The Town of Rolesville  
Michael Elabarger, Senior Planner  
P.O. Box 250  
Rolesville, North Carolina 27571

RE: **The Point – Phases 1, 2, 6, & 9**  
**FSP 23-04**  
**Response to 1<sup>st</sup> Final Subdivision Plat Review Comments**  
**AWH-20000**

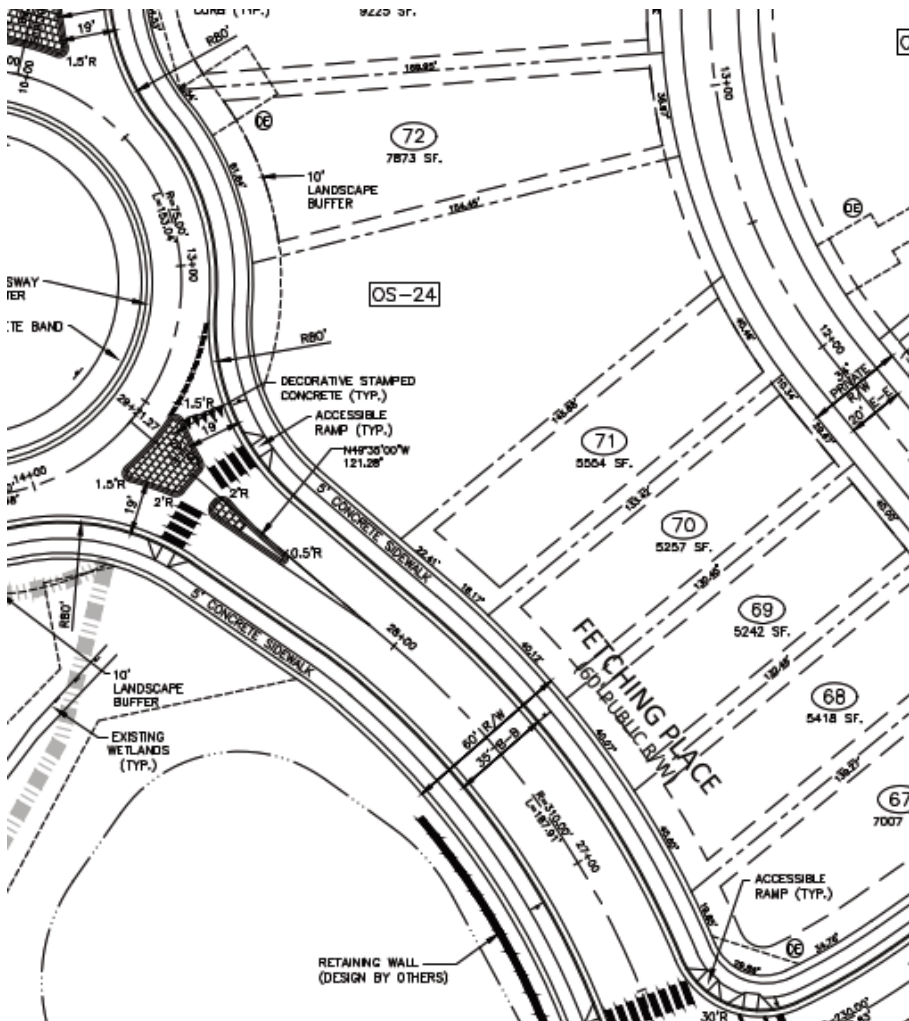
13. Please include the graphic scale on this sheet.

**McAdams Response: Scale added.**
